# Review 1

## Major Site Plan Zara Realty, LLC (Mohammad Chaudhry)

7 West 8th Street  
Block 283, Lot 23.01  
8<sup>th</sup> Street Rehabilitation Area  
Broadway Business District Sub-Area  
Office/Retail Service District (ORS)

April 2, 2024

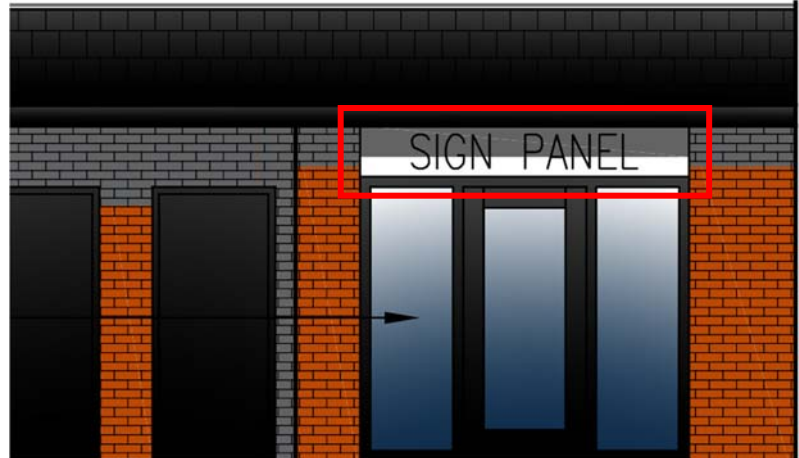
- 5.1. **Proposed Wall Sign.** The plan indicates one sign associated with the ground floor retail space. The sign is indicated generically as shown in the accompanying image (outlined in red).

Signs are permitted as regulated by §35-25 of the Ordinance. Per §35-25.4C.1, wall signs, not exceeding three sf. for each linear foot of sign frontage is permitted. The plans indicate ±8 linear feet of sign frontage, which permits 24 sf. of sign area. 10 sf. is proposed. The plan complies. **As a condition of any approval, the applicant should require any future tenant to have signage in line with what is proposed in the plan and conforming with §35-25.**

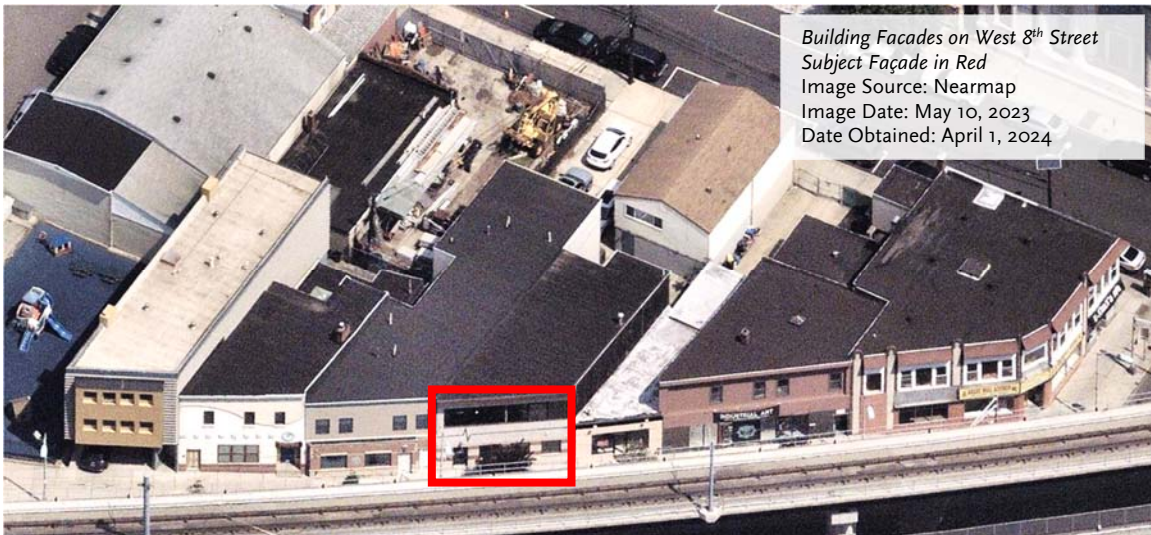
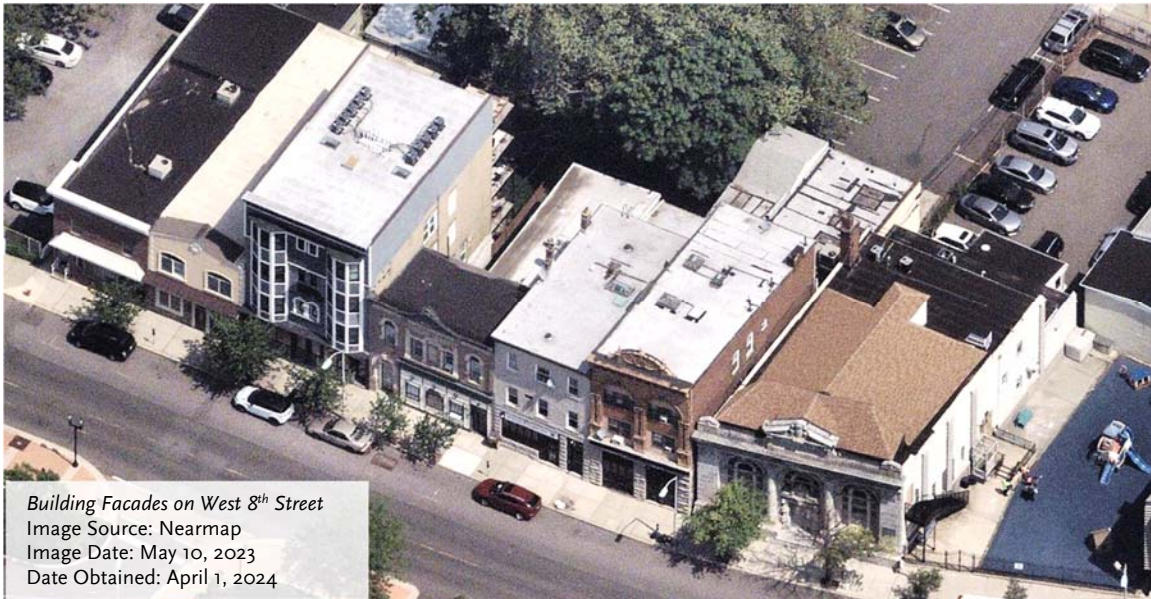
- 8.1. **Building Design - Exterior.** The proposed building is five stories in height. The ground floor is design with a façade of red brick but contains three doors so the effect is more like pilasters, than an expanse of brick wall. The easternmost door is composed of glass and is to be utilized by the commercial space. The central door leads to a vestibule to be used by residents to access the apartments and ground floor amenity space. The third, westernmost

door leads to the utility/meter room. The central and western door are solid black doors. While we understand why the mechanical room has a solid door, the door to the lobby should also be glass. This glass could be opaque, but aside from identifying it as a normal and would identify the entrance for use by residents and visitors to the apartments. Perhaps, most importantly, however, persons inside the building need to see if there is anyone standing in front before opening the door. With a solid door, that will not be possible unless the applicant is proposing an external camera and internal monitor of the exterior of the building. The proposed façade sign is above the commercial entrance, and above that is a canopy that extends the width of the building over the ground floor. Above the ground floor the building exterior is composed of white vinyl siding. Each apartment has a front facing balcony that is recessed into the façade and fenced with a black balustrade. To the right of each balcony are three front facing windows. There are four balconies and 12 windows. The façade is capped by a white cornice. The sides and rear of the building utilize the same white vinyl siding. The sides do not have windows. The rear has two windows per residential floor. The ground floor has a rear entrance and a smaller rear window. There is nothing edifying about this design that consists of the lowest common denominator of building materials, aside from the ground floor. Additional comment concerning this design is found below.
